**AGENDA**  
**PLANNING AND ZONING COMMISSION WORK SESSION**  
**City Hall, 385 South Goliad, Rockwall, Texas**  
**Council Chambers**  
**June 25, 2019**  
**6:00 P.M.**

**MINUTES**  
**PLANNING AND ZONING COMMISSION WORK SESSION**  
**City Hall, 385 South Goliad, Rockwall, Texas**  
**Council Chambers**  
**May 28, 2019**  
**6:00 P.M.**

SHEET NO:  
**LP.01**

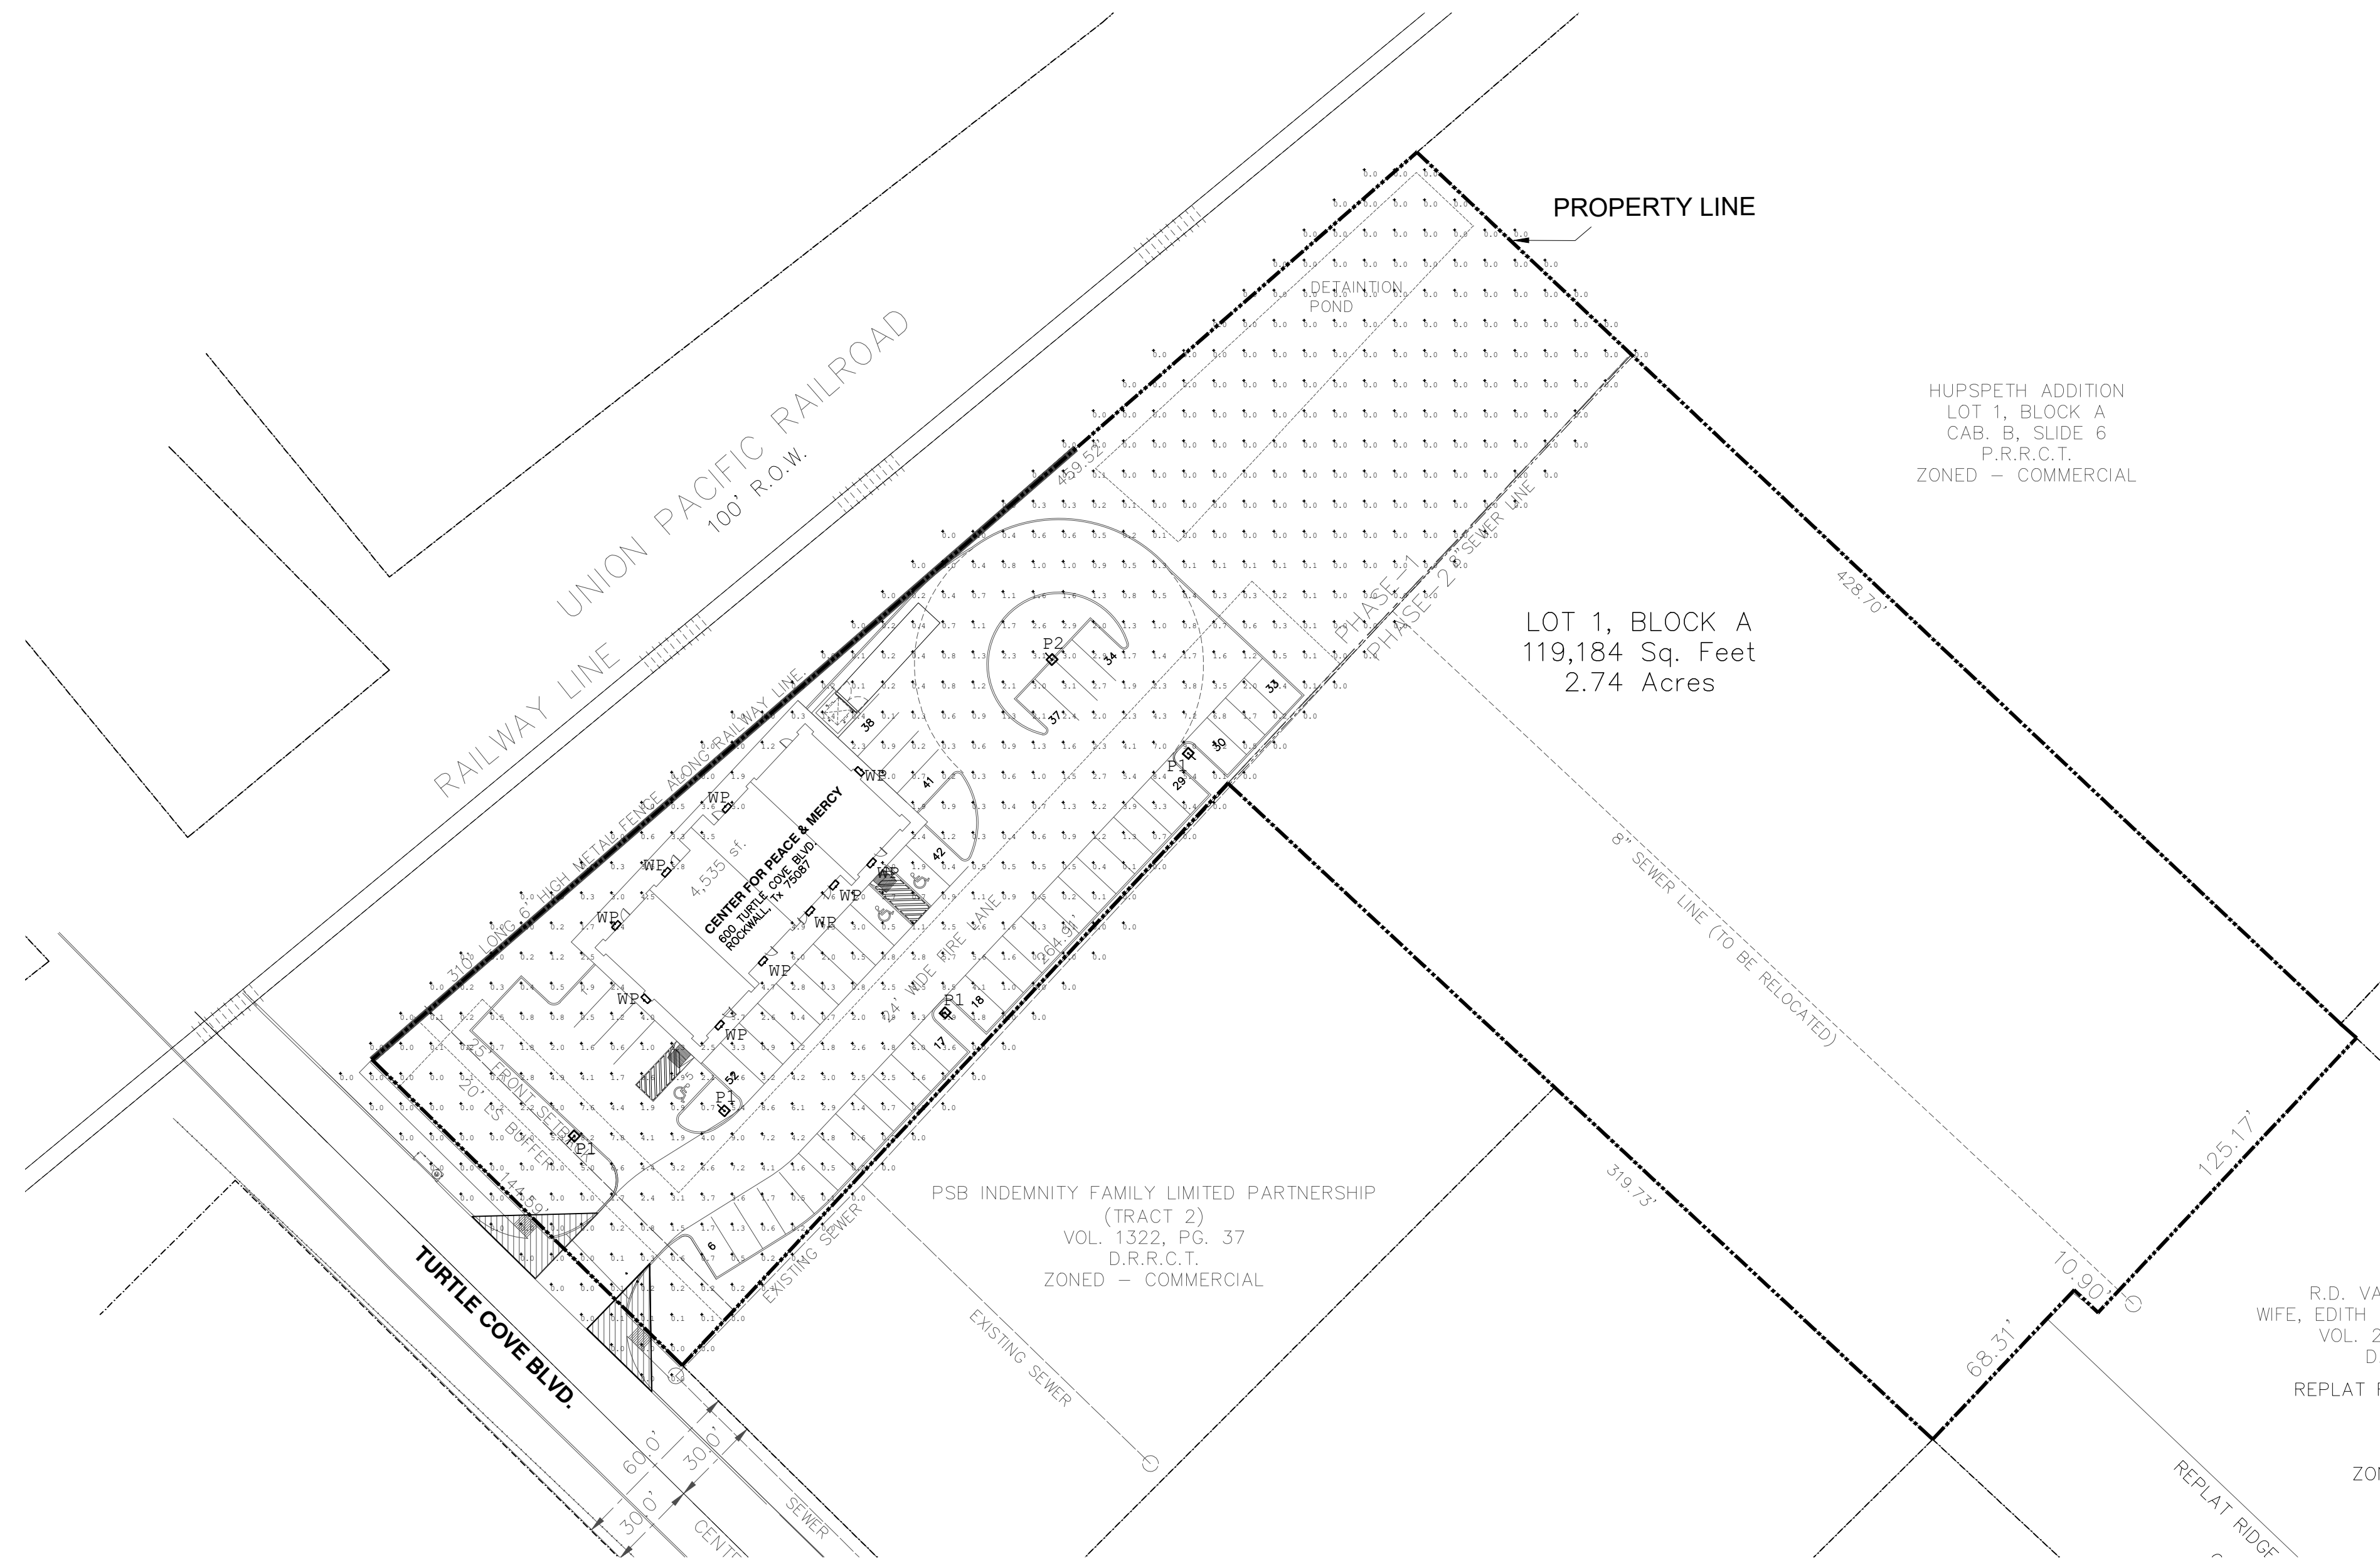
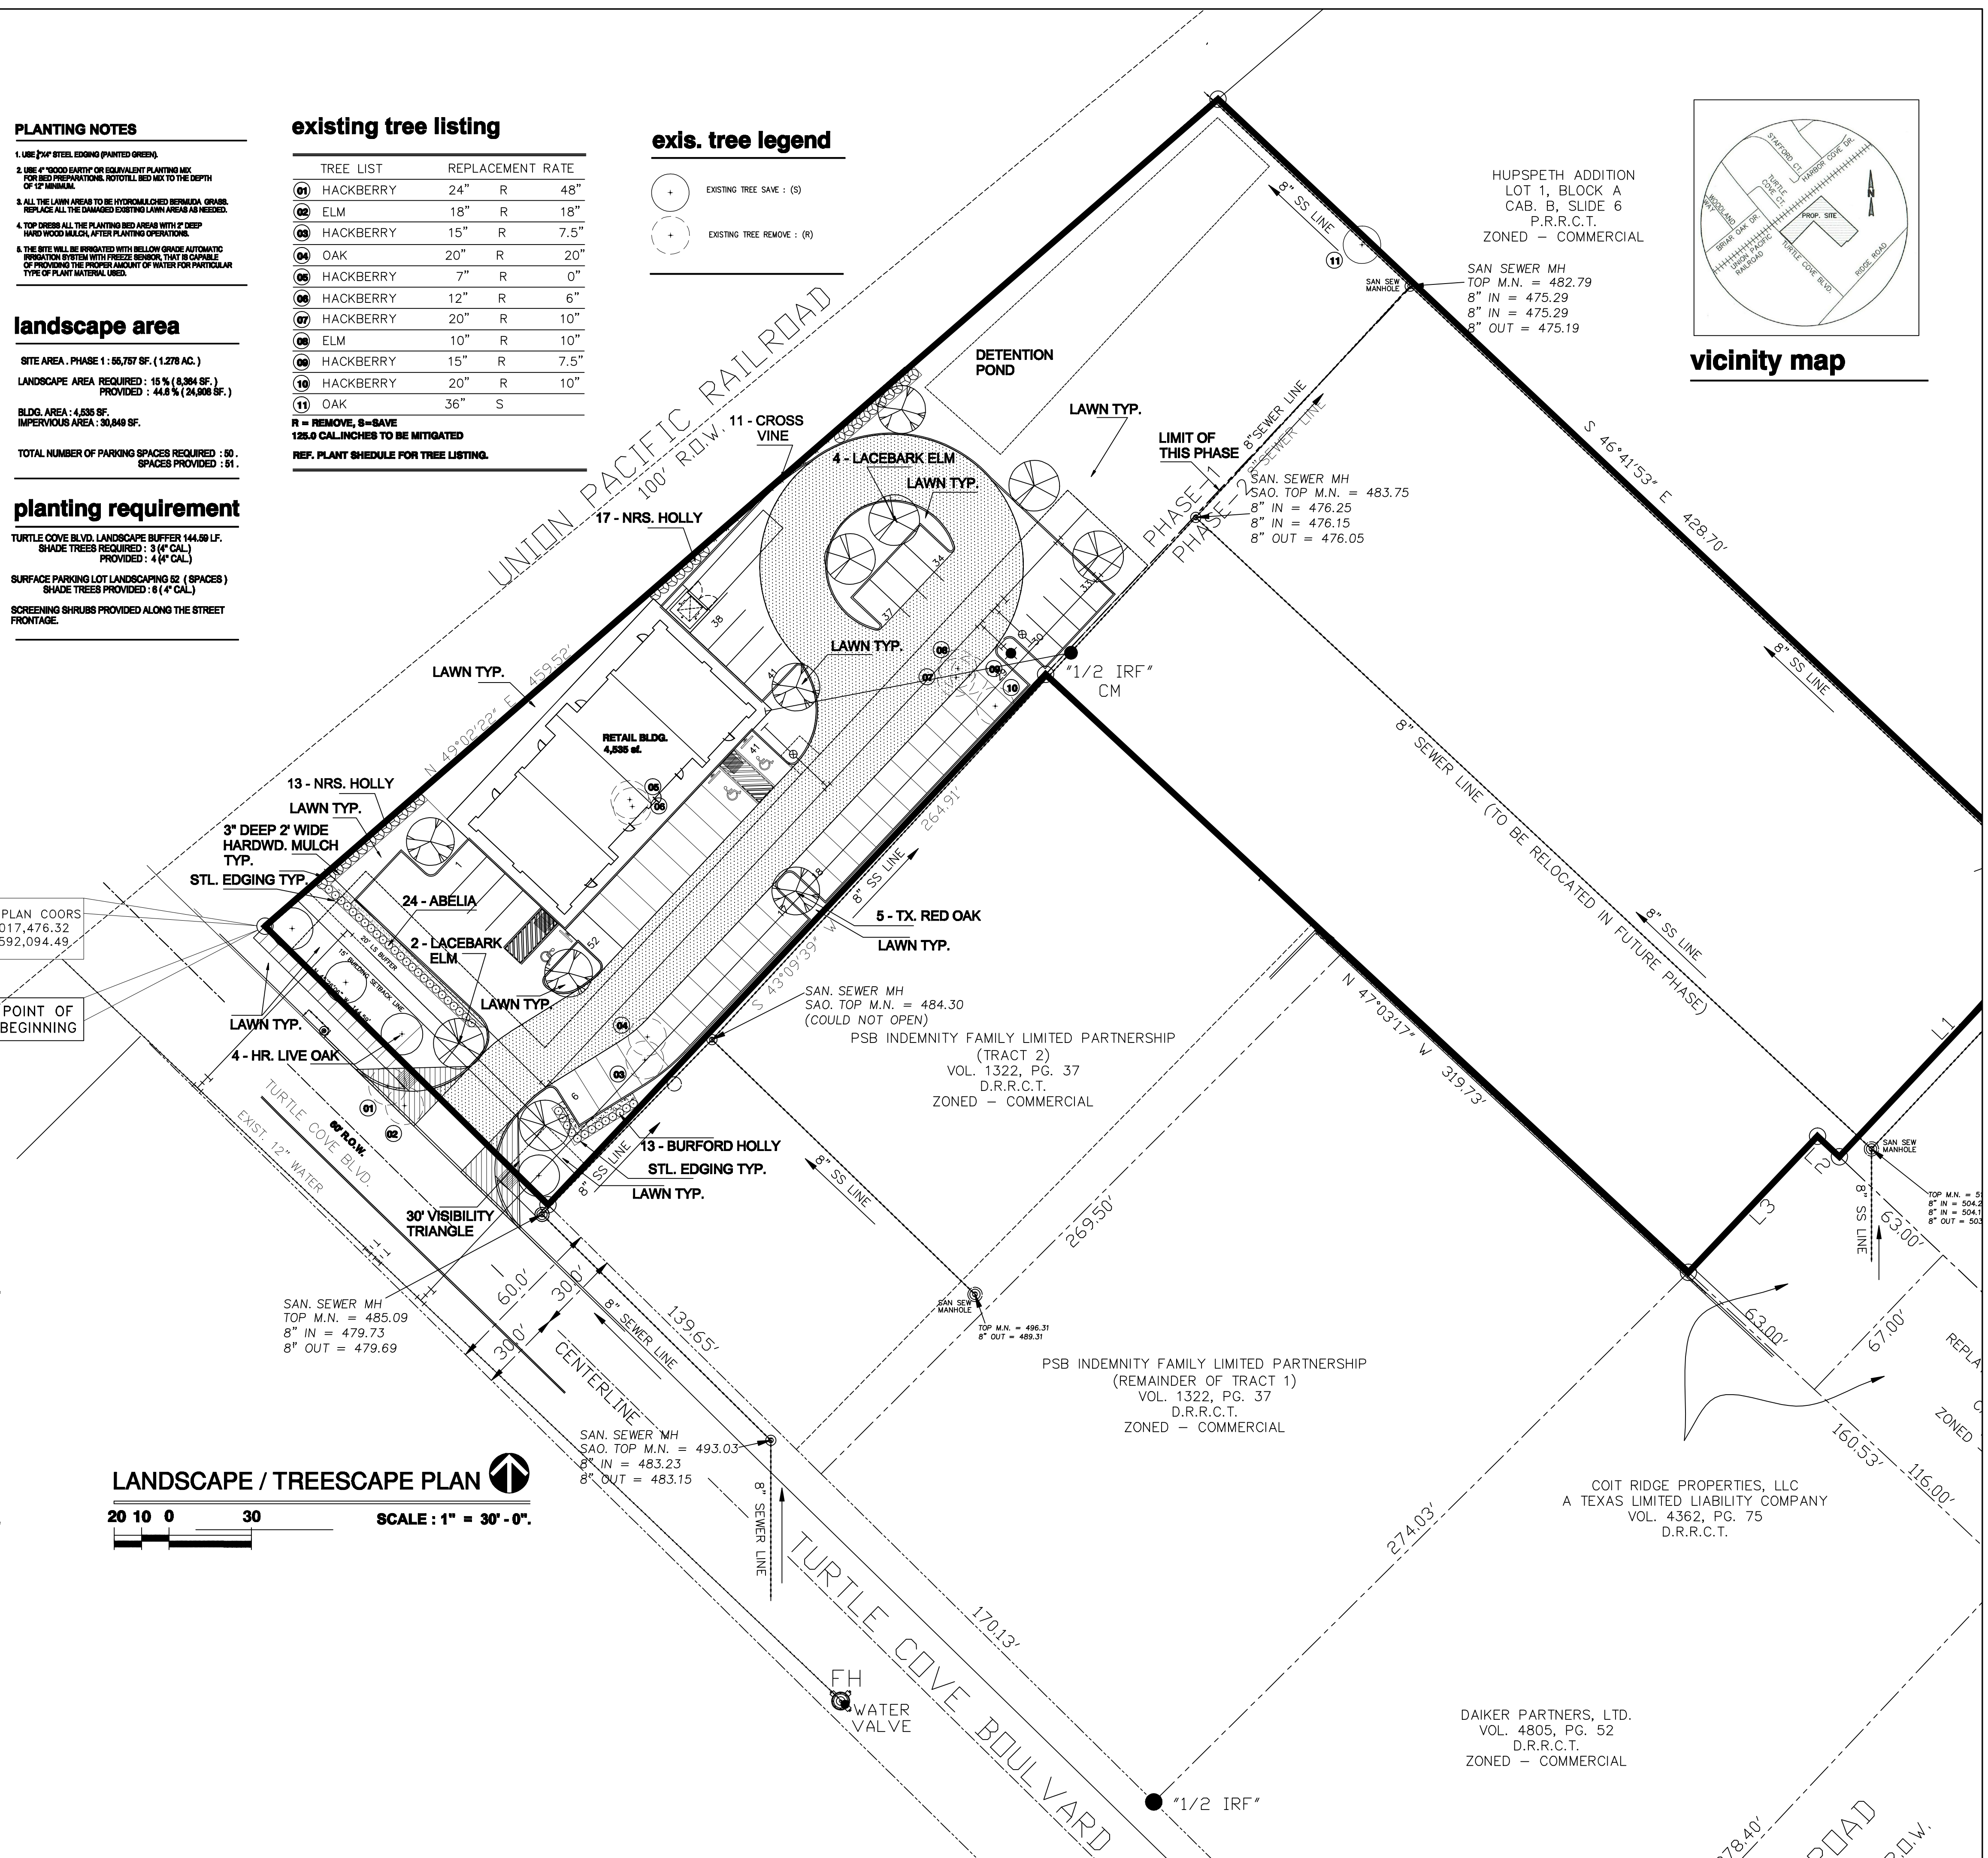
Type of Review / Notes	Contact	Sent	Due	Received	Elapsed Status	Remarks
28.	Sheet LP.01					—please dimension a typical parking space—also as noted, parking must be 9x20.

29.	Sheet LP.01					—The parking and building can be greyscaled so that the landscape plan focuses on the landscaping.
30.	Sheet LP.01					—Please note that the landscape buffer is 20-feet and the building setback is 15-feet.

31.	Sheet LP.01					—Please provide the actual footprint of the building (i.e. show any projections or recesses).
32.	Sheet LP.01					—Please provide adjacent property information as shown on C-1.

33.	Sheet LP.01					—Please darken and label property line for subject property.
34.	Sheet LP.01					—There several dashlines toward the SE of the property that are not labeled. Please label all lines, provide a variety of lineweights/types. A legend can be provided in lieu of labeling each line. As drawn, the utilities and property lines, ROW, etc. have the same line weight and type.

35.	Sheet LP.01					—There are several dark circles with a line projecting and several open circles. Please label or provide a legend.
36.	Sheet LP.01					—As on Sheet C-1, please show firelane as a shade of grey and any remaining concrete as a lighter shade of grey. Please use the stippling pattern currently being used on the firelane to show where grass will be.

37.	Sheet LP.01					—Please add site data table as mentioned above. Some of the needed information is already being provided on the sheet; however, please replace with the same data table so that all sheets have the same data table/same information.

38.	Sheet LP.01					—Please darken visibility triangles
39.	Sheet LP.01					—What are the two hatched areas at the end of the parking toward the rear of the building?

40.	Sheet LP.01					—For consistency purposes, please change title from Planting Plan to “Landscape/Treescape Plan”
41.	Sheet LP.01					—Please note that the min caliper inch for trees is 4-inches.

42.	Sheet LP.01					—Please note that headlight screening may be required along the property line adjacent to the RR.
43.	Sheet ESP					—Please removed the details of the light pole. Just show the pole from the ground up and provide height.
